Norwich to Tilbury

Targeted consultation

Location reference: [Thurrock 2](#) 12 noon 25 February 2025 to 11:59 pm 27 March 2025

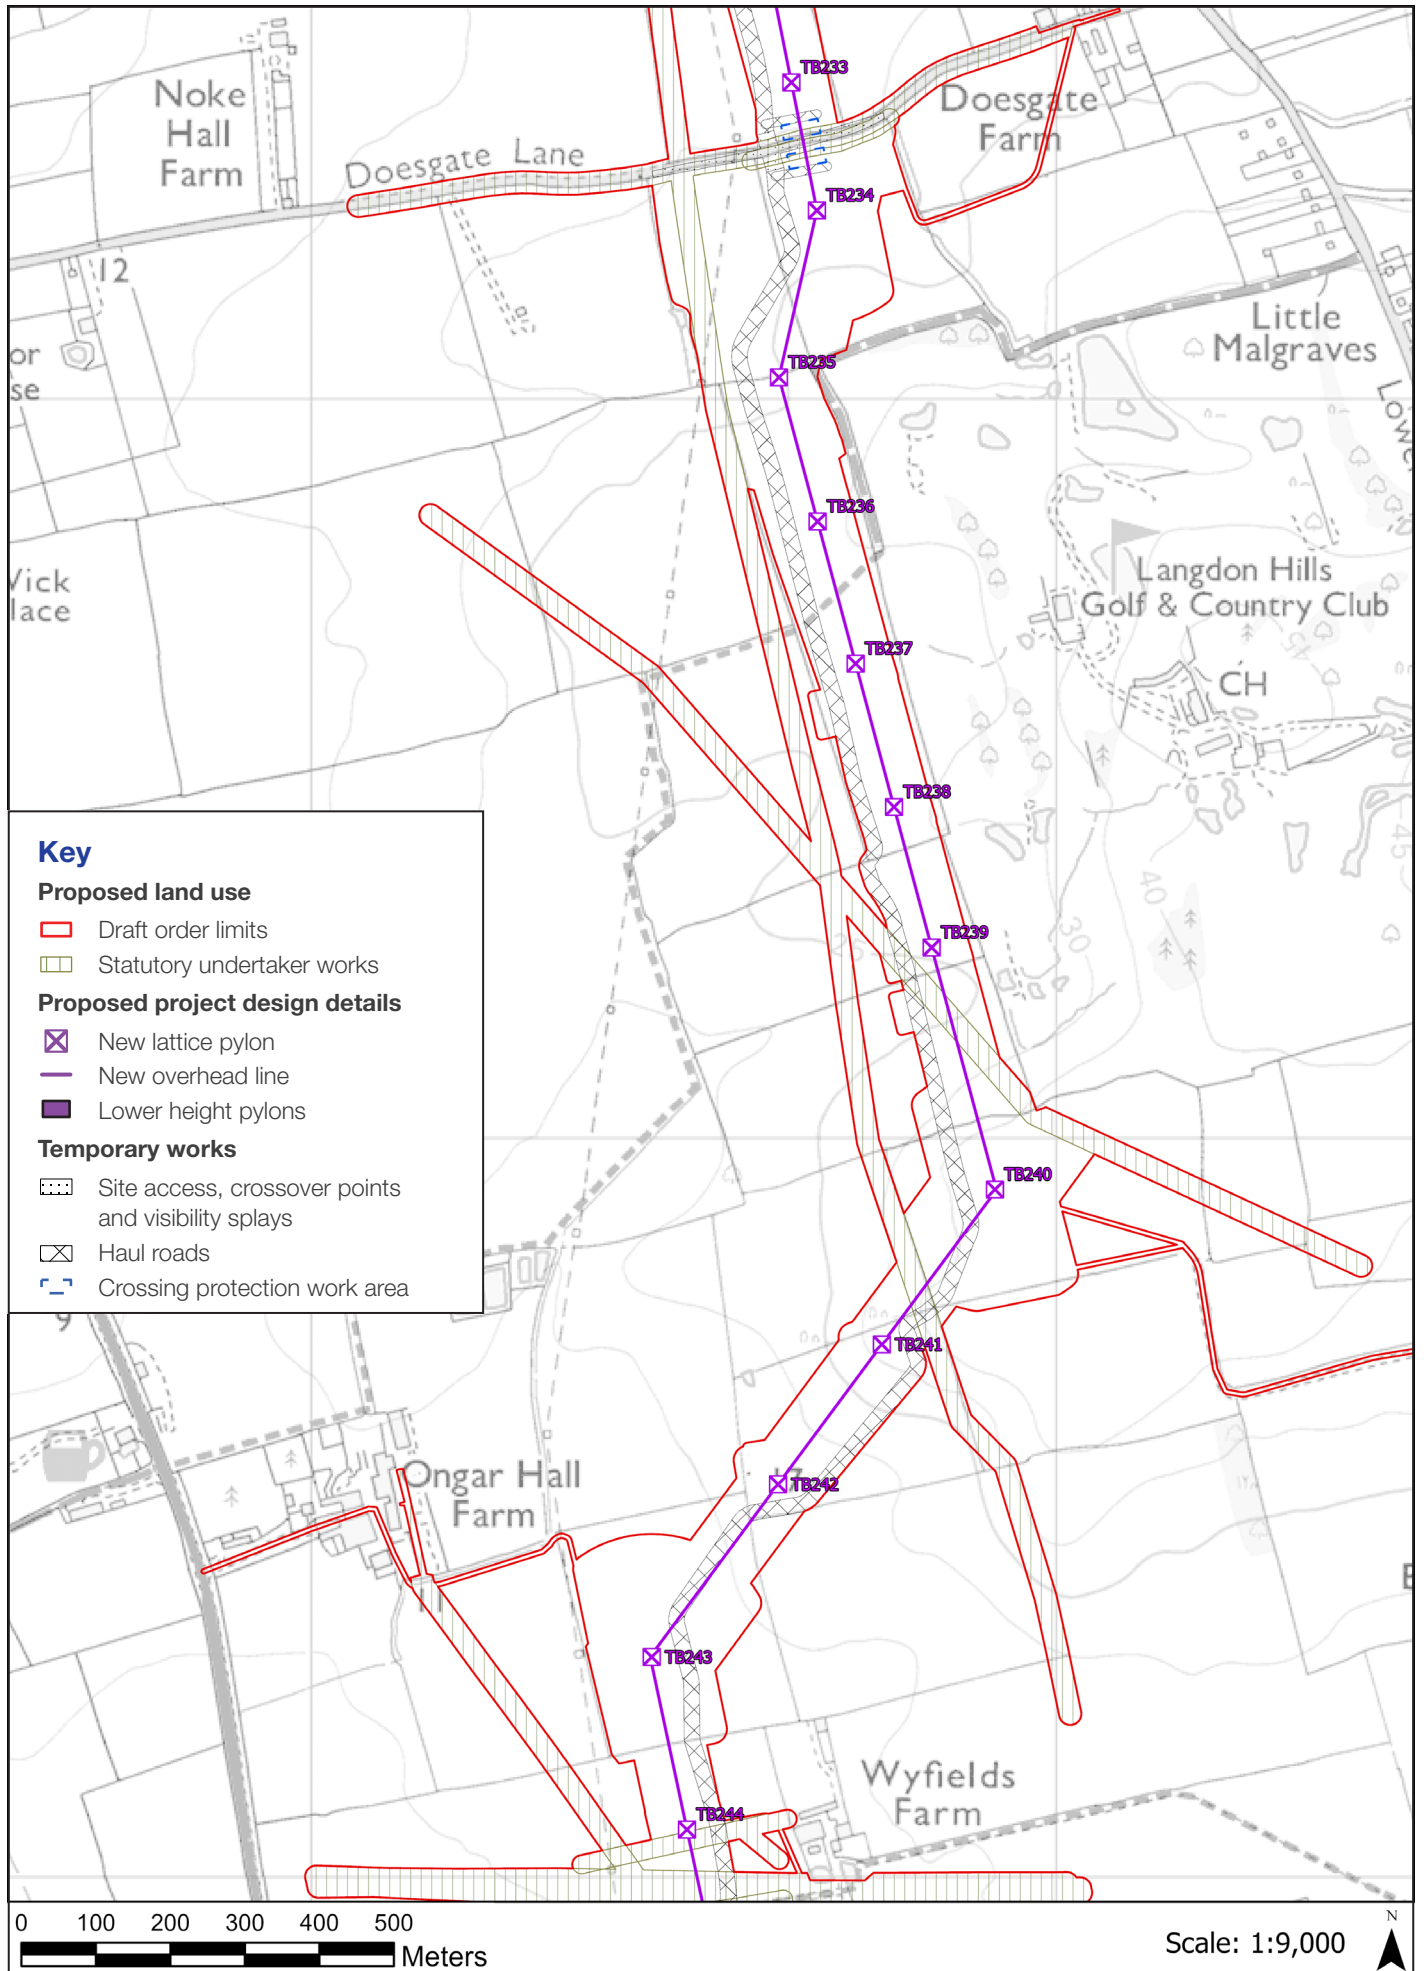
We are proposing to reposition the alignment of the overhead line to allow the close paralleling of the existing 132 kV overhead line near Langdon Hills Golf Club. The proposed change involves the relocation of pylons TB238 to TB244 (previously presented at statutory consultation as TB235 to TB243) to more closely follow the route of the 132 kV overhead line.

We are also proposing to use lower height lattice pylons from TB238 to TB243 (previously presented at statutory consultation as TB235 to TB242) to reduce the impacts on Thurrock Airfield. You can see the proposals presented at our statutory consultation in summer 2024 and our proposed changes on the maps overleaf.

Area of proposed change February 2025

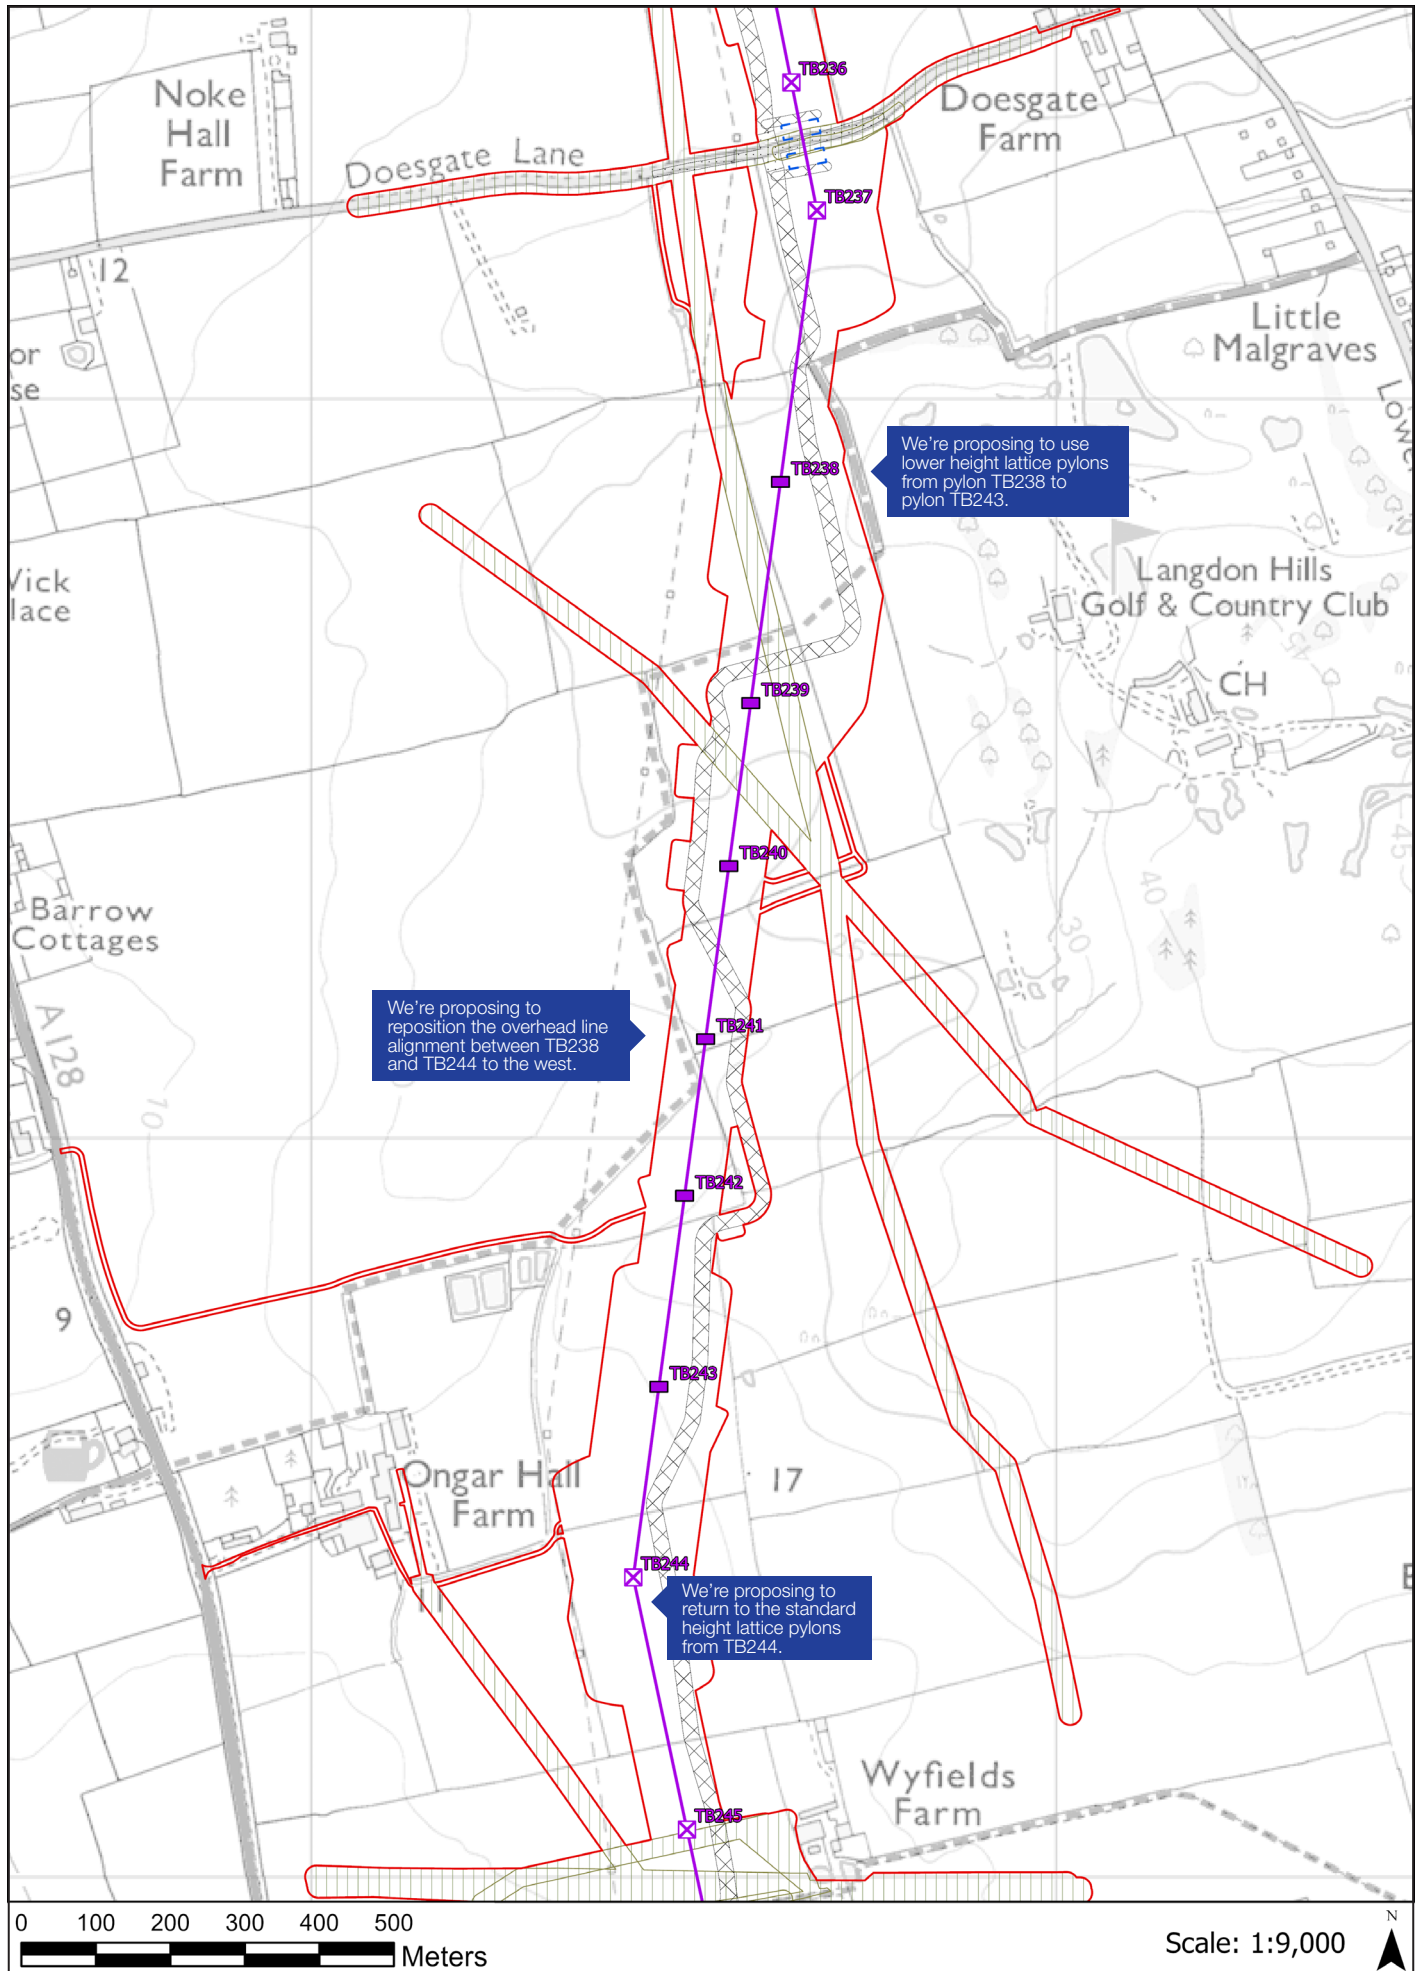
Alignment presented at the 2024 statutory consultation
